SEWAGE DISPOSAL SYSTEM

HOWARD COUNTY HEALTH DEPARTMENT
BUREAU OF ENVIRONMENTAL HEALTH
410-313-2640

SUBDIVISION Lyndonbrook LOT NUMBER 29 ADDRESS 2112 Whitman Way

PLAN TO ACCOMPANY APPLICATION
FOR BUILDING PERMIT

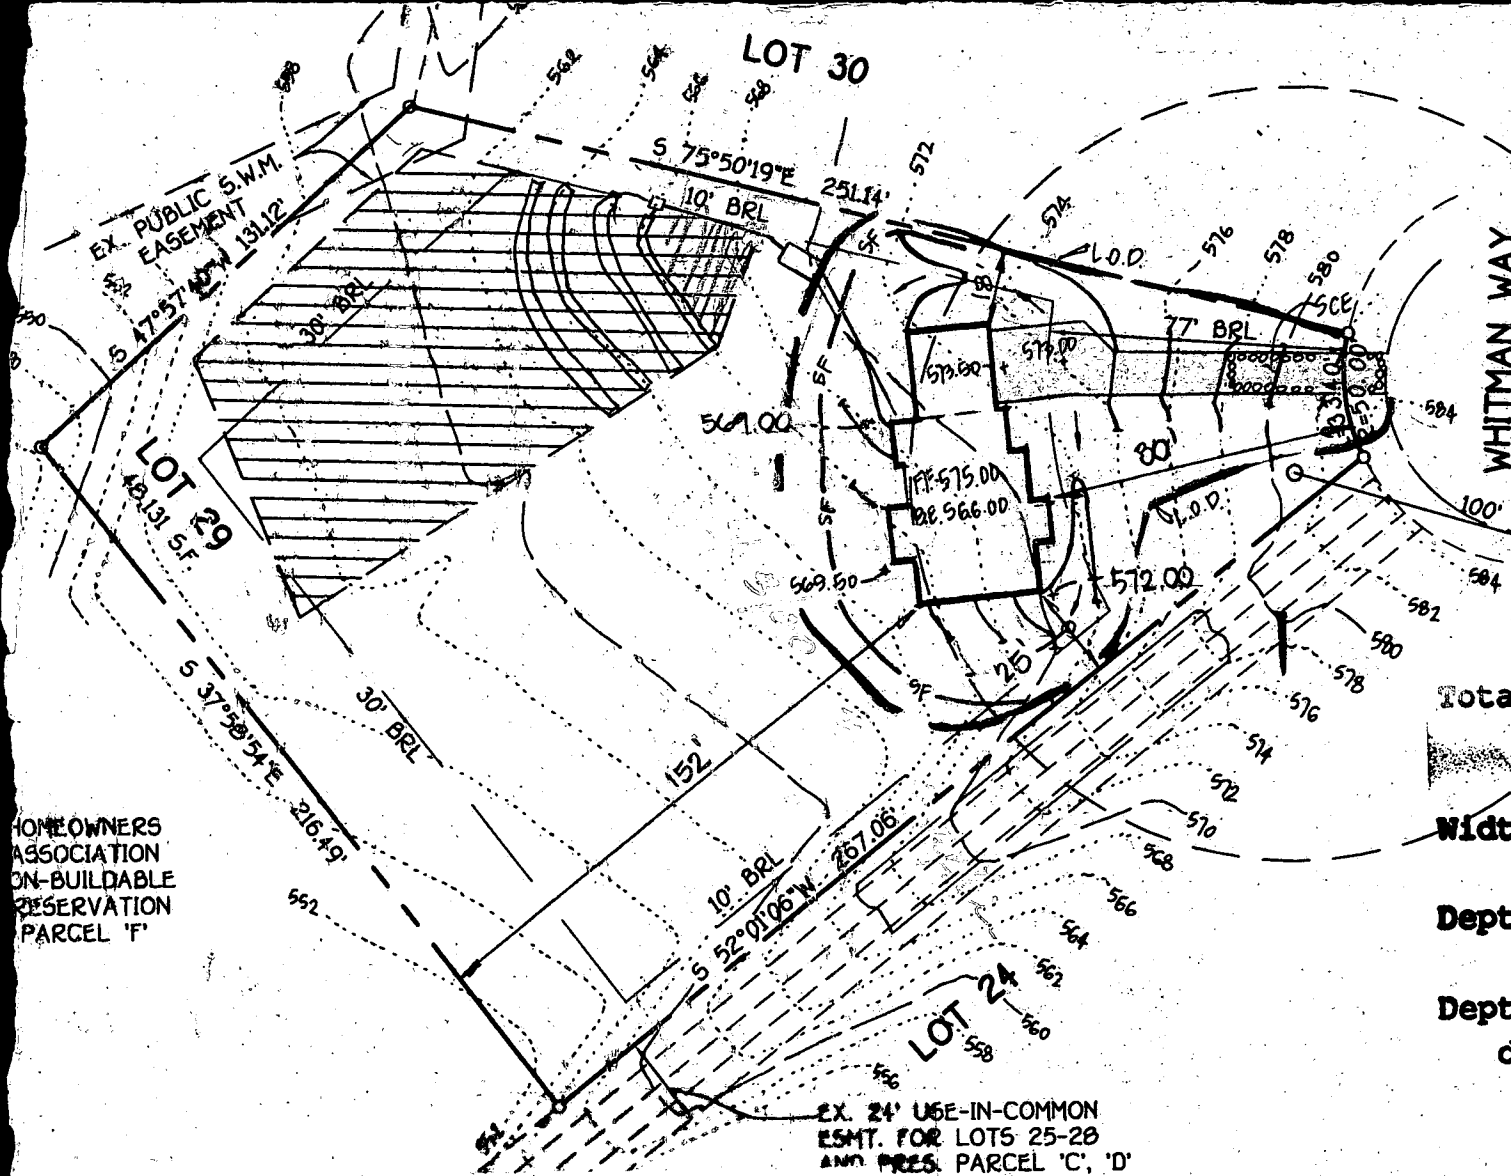
PRE-CONSTRUCTION INSPECTION: 8/17/00 Install to move septic tank.
contour differs from PP plan. OK to continue. DCS

INSPECTION COMMENTS: 8/18/00 House connection made. Trenches may be 6" deeper
than intended and have a little extra spacing due to difficulty
working with contour. (BB) 8/21/00 System satisfactory. O.K. to
cover everything. (BB) (MR)
